Pentium® II Xeon™ Processor Specification Update

Release Date: January 2000

Order Number: 243776-019

The Pentium® II Xeon™ processor may contain design defects or errors known as errata which may cause the product to deviate from published specifications. Current characterized errata are documented in this Specification Update.

Figure 1. An Example of Microcontroller Driven Thermal Management

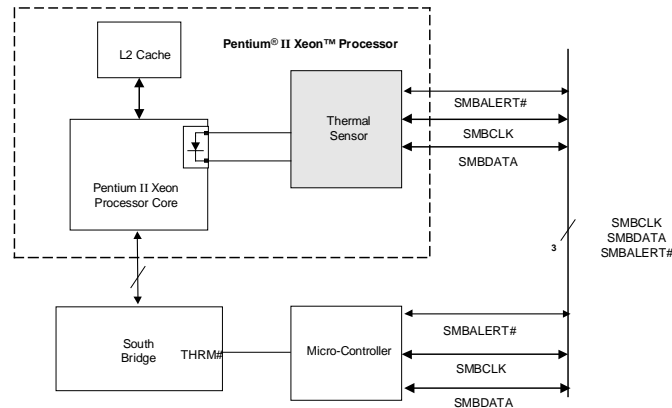
D30. Thermal Sensor May Assert SMBALERT# Incorrectly

Problem: The Pentium II Xeon processor has a thermal sensor that monitors the processor core's temperature. The thermal sensor asserts SMBALERT# if the processor temperature exceeds the temperature limits set in the Alarm Threshold Registers (T_{HIGH} , T_{LOW}). It also sets the corresponding Status Register bits to identify the cause of the interrupt. Figure 1 gives one example of the how the SMBALERT# signal could be used in a system.

Under the conditions described below, the thermal sensor incorrectly generates the SMBALERT# interrupt. All of the following conditions must be met to trigger a false interrupt:

Workaround: Three different (mutually exclusive) workarounds are possible:

1. Before servicing an interrupt from the thermal sensor, read and compare the processor thermal reading with the threshold limits (T_{HIGH} or T_{LOW}). Figures 2 and 3 provide basic flowcharts for the implementation of this workaround in an interrupt driven system.
2. If the firmware implemented polls the Status Register only, then before taking any action, re-read the temperature register and do a comparison with the alarm threshold limits (T_{HIGH} or T_{LOW}) to determine if the value is actually still within the temperature window.
3. Use a temperature polling scheme to monitor the processor temperature
